ILLINOIS POWER COMPANY

Subject: Clinton Power Station Unit 1  
SER Outstanding Issue #9  
SER Confirmatory Issues #13, #71  
Suppression Pool Hydrodynamics

## Attachment

FIGURE 1.0

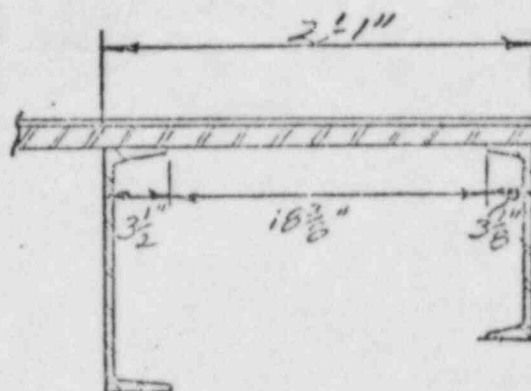
- a) Justify why CPS has used the pool swell shape, as predicted by the GE-performed SOLA analyses, to make modifications to the present encroachments (i.e., extending the existing structure further away from the drywell wall over the suppression pool).
- b) Justify the use of 115 psi as the impact load for beams used on the 737' elev. floor extension over the suppression pool.

- a) Illinois Power has transmitted the justification for the encroachment extension as part of the Humphrey Issues. (Reference Letter U-0714, D. I. Herborn (IP) to A. Schwencer (NRC), dated May 25, 1984). As a member of the Containment Issues Owners Group, (CIOG), Illinois Power's involvement to resolve the validity of SOLA is still in progress.
- b) The encroachment modification at 737'-0" elev. of the containment has been designed for a 115 psi impact load. The exposed surfaces of the encroachment's S-sections, C-sections, and the plates supported by the C-sections are illustrated in Figure 1.0 (attached). As shown, all the widths of these exposed sections are less than 20". Therefore, these sections were designed to the load definition of "small structures," which is 115 psi.
